KV6\KV8 Series Villa Door Station Firmware

V2.2.53_220816 Release Note

Device Model	DS-KV6103-PE1(B)、DS-KV6113-PE1(B)、DS-KV6113-WPE1(B)、DS-KV8113-WME1(B)、 DS-KV8213-WME1(B)、DS-KV8413-WME1(B)
Firmware Version	V2.2.53_220816
iVMS-4200 Version	Latest version
Hik-Connect APP	Latest version

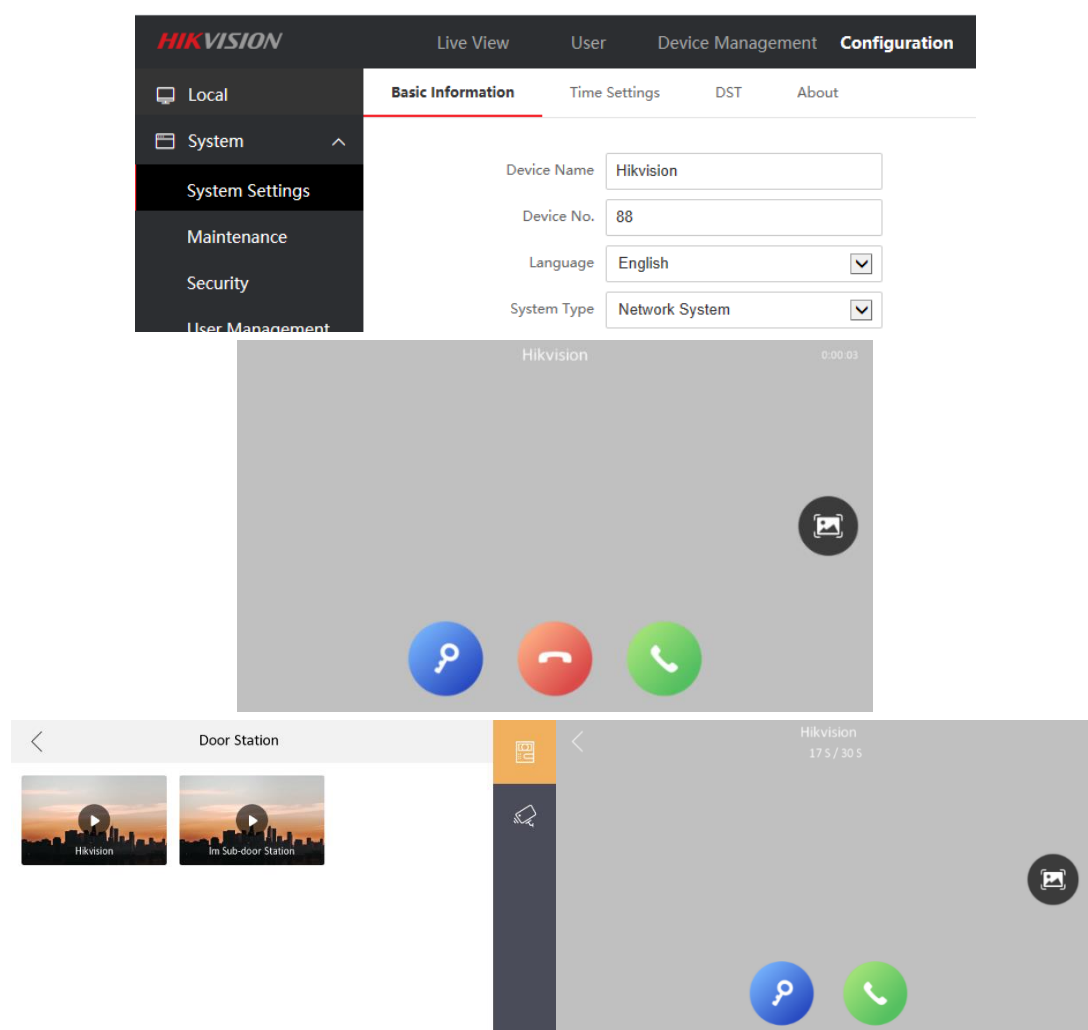
1. The changed name of the door station will be displayed on the call interface or live view interface of the indoor station

2. Add indoor station or sub-door station to iVMS-4200 or WEB to add default value

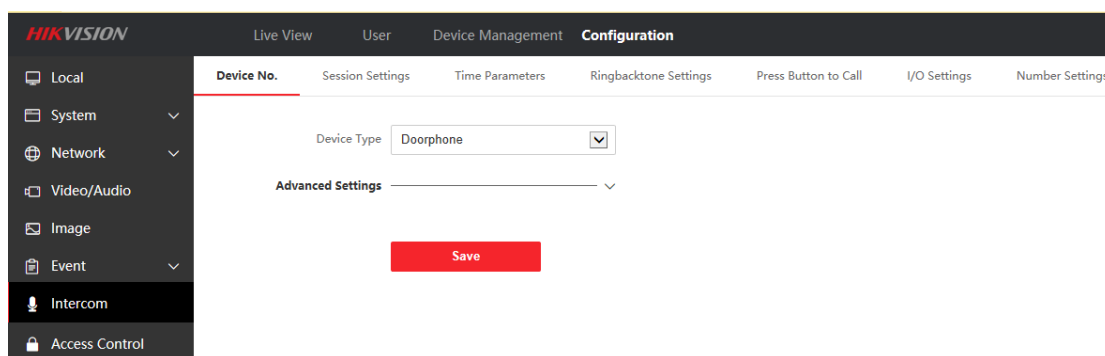
- Support doorphone mode, when this function is enabled, the door station will no longer actively synchronize the information of the indoor station

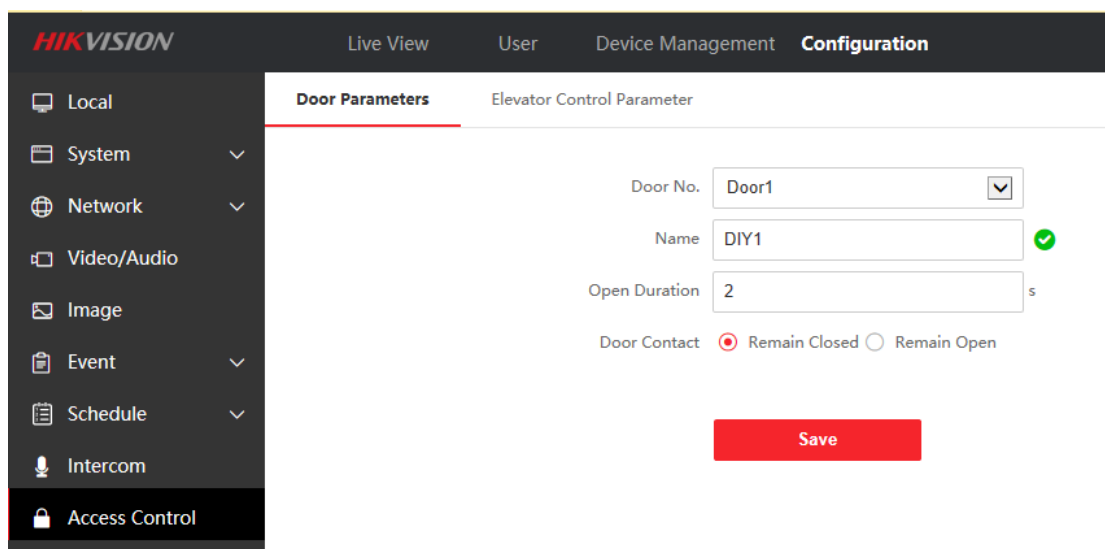
- Both Lock 1 and Lock 2 support custom names

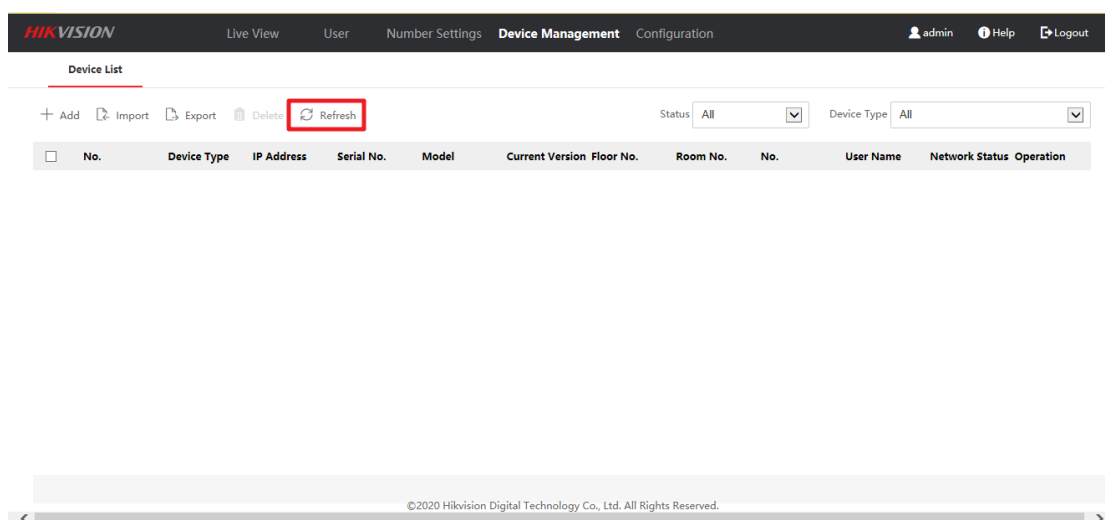
1. New refresh button is used to refresh the status of added devices

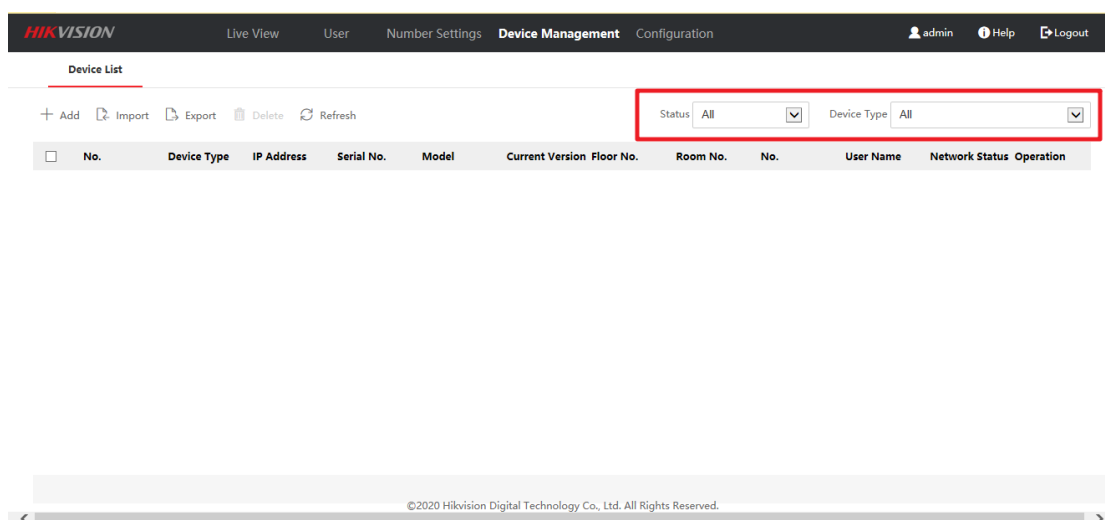
2. Added 'All' option, indoor station and sub-door station will be displayed together.

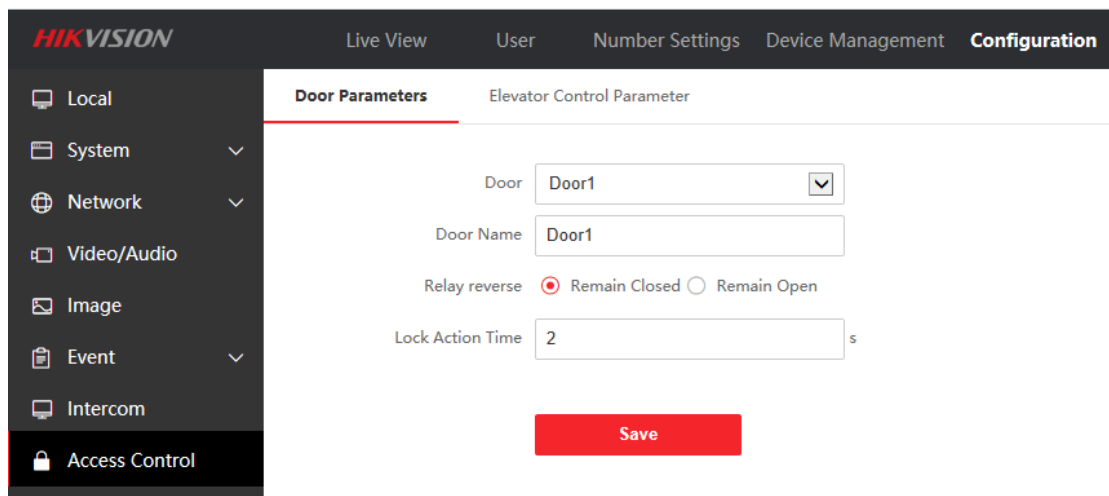
1. Modify the default unlocking time to 2 s, and supporting unlocking time can be configured with 1-255 s

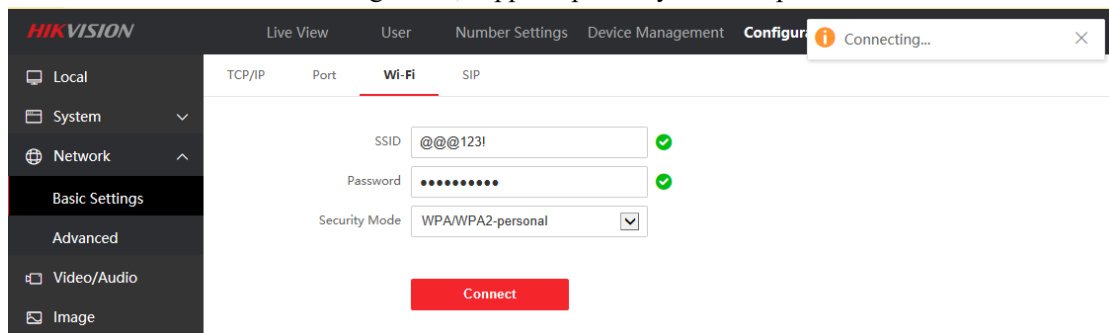
2. When villa door station adding Wi-Fi, support special symbols as password

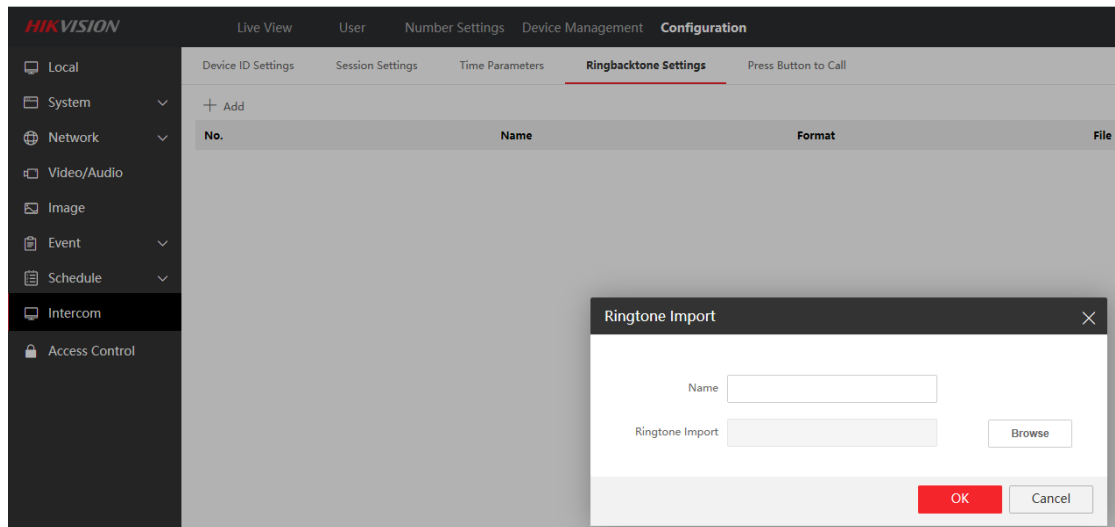
b. Support 1 holiday group and 16 holiday plans

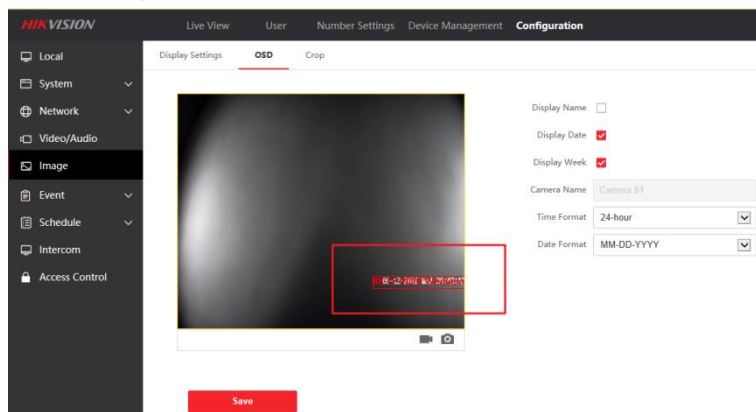
a. The door station can open different locks through the external card reader (or card reader module KD-M, KD-E) different DIP Switch dial codes. When the dial code is not 2, open lock 1, and when the dial code is 2, open lock 2.

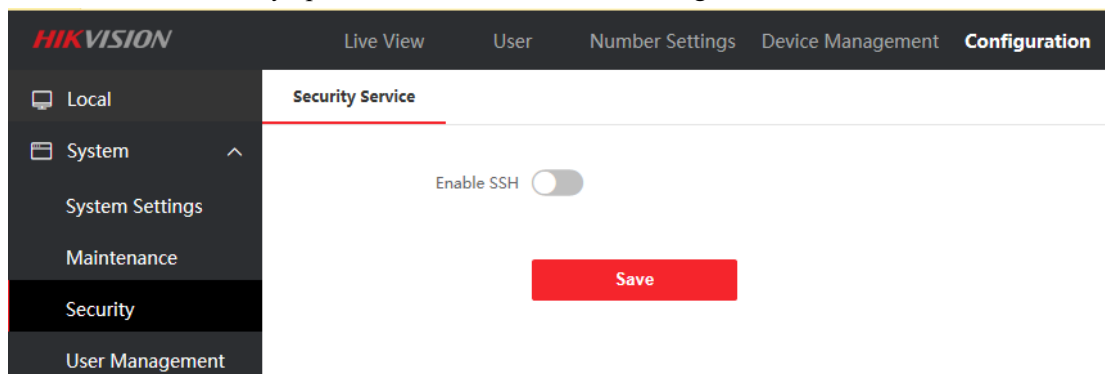
2. The default position of the OSD is adjusted to the lower right corner. When performing intercom with the master station and indoor station, the default OSD will not block the existing key information;

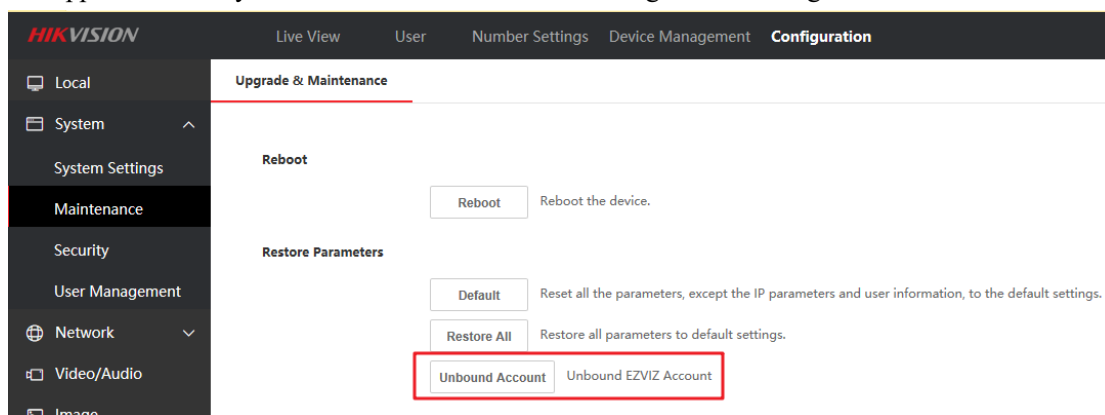
3. The user can remotely open the device SSH function through the WEB;
